The IEEE Reliability Test System - 1996

A report prepared by the Reliability Test System Task Force of the Application of Probability Methods Subcommittee

Discussion

A. W. Schneider, Jr. (MAIN Coordination Center, Lombard IL):

Figure 5 - Single Line Diagram of IEEE One Area RTS-96 Substation System

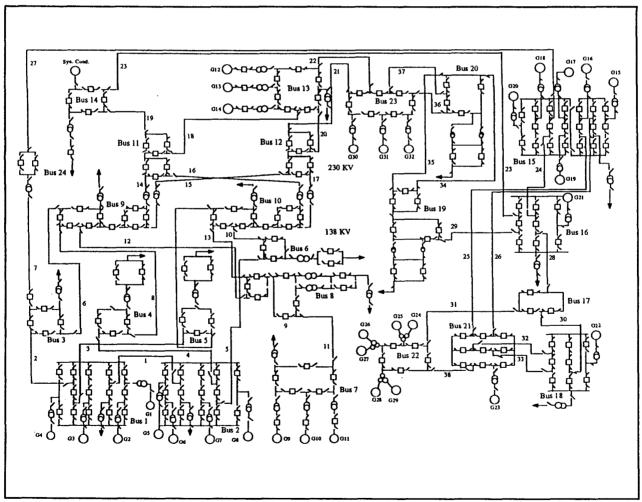
- 2. The capacity of the optional DC line should be shown in Table 13.
- 3. The tap ratio of the generator stepup transformers should be specified in Table 15 or a footnote, even if unity is intended.
- 4. Figure 5 has two omissions which must be resolved to define a valid RTS configuration.
- The connection of the 100 MVAr reactor at bus 6 is not shown.
- The configurations of buses 3, 7, 13, 15, 17, 18, 21, and 23 make no provision for inter area tie line terminations, which do not appear in corresponding buses in every area.
- 5. No outage nor restoration rates are provided for the transformers supplying load, whether 230 kV or 138 kV. Specifying their impedances, tap ratios, and load tap changing characteristics would be a desirable addition.

Several of the substation configurations are more complex (hence, costly) than is needed and at the same time less reliable than simpler alternatives. While it need not be a goal of the RTS to present an optimum configuration at each bus, it is reasonable to avoid redundant breakers and unnecessary exposure to loss of all sources or all outlets to a bus from a single fault. Such exposure may distort the contribution to reliability indices of untypical failure modes.

- An unneeded line breaker connects line 7 to bus 3.
- Distribution system (under 138 kV) data is not generally provided by the RTS. A consistent technique of either showing transformers feeding load, as at but 15, or omitting them as at but 20, should be adopted. Paralleled breakers and/or transformers, as at buses 6 and 8, raise issues for which the RTS data is completely inadequate.

- The configurations of buses 9-12 are unnecessarily complex and unreliable. All these buses have the "supplies" grouped on one side of a critical element and the "loads" grouped on the other side. Loss of the common element will result in total interruption of supply from the 230 kV to the 138 kV system through the affected bus. Configuring each of these buses as a simple ring bus would be less costly and more reliable.

- Similarly, bus 8 has its sources from buses 9 and 10 grouped together and is susceptible to isolation by a single event.
- At bus 22, exchanging the connection of G26 and G27 with line 38 would eliminate the possibility of all generation at this station being lost from a single fault on a breaker.
